# TOWN OF MEDWAY COMMONWEALTH OF MASSACHUSETTS

## **DESIGN REVIEW COMMITTEE**

March 22, 2023

RE: DRC Comments - Dunkin Signage 81A Main Street

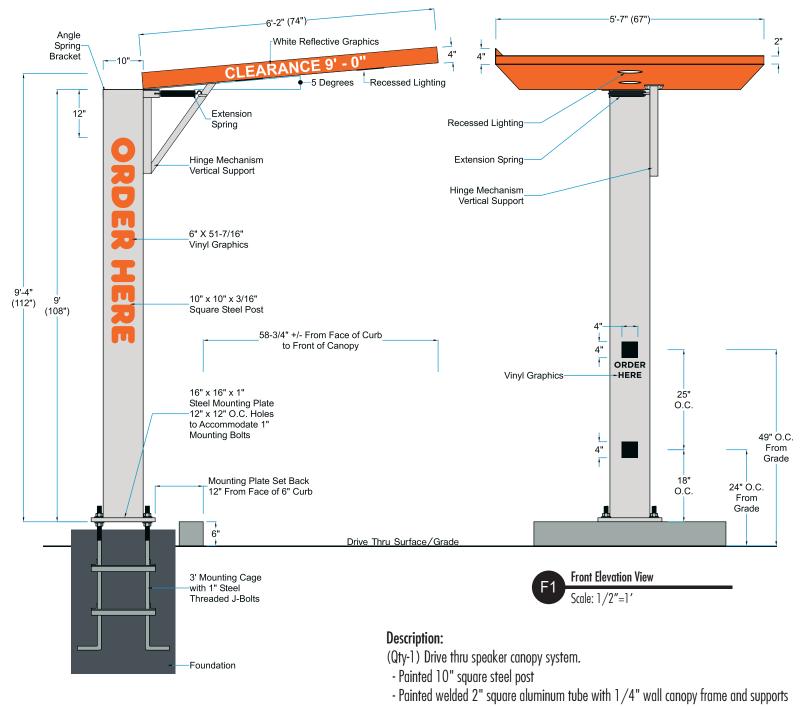
- Lower the façade signs below the height of the existing parapet, off of the façade's raised section to comply with the sign regulation section of the *Zoning Bylaw* which prohibits roof signs.
- Eliminate the east facing wall sign (**SOMETHING FRESH IS ALWAYS BREWING**) to comply with the quantity of wall signs permitted by the Sign Zoning Bylaw.
- Adjust the message on the directional signs to **ENTER** and **EXIT** only without any graphic logo.

Viewpoint Signs incorporated the above noted DRC recommendations into the revised sign package submitted on March 13<sup>th</sup> and reviewed at the March 20<sup>th</sup> DRC meeting. (**See Attached**.) We appreciate the collaborative nature of the discussion and sign revisions.
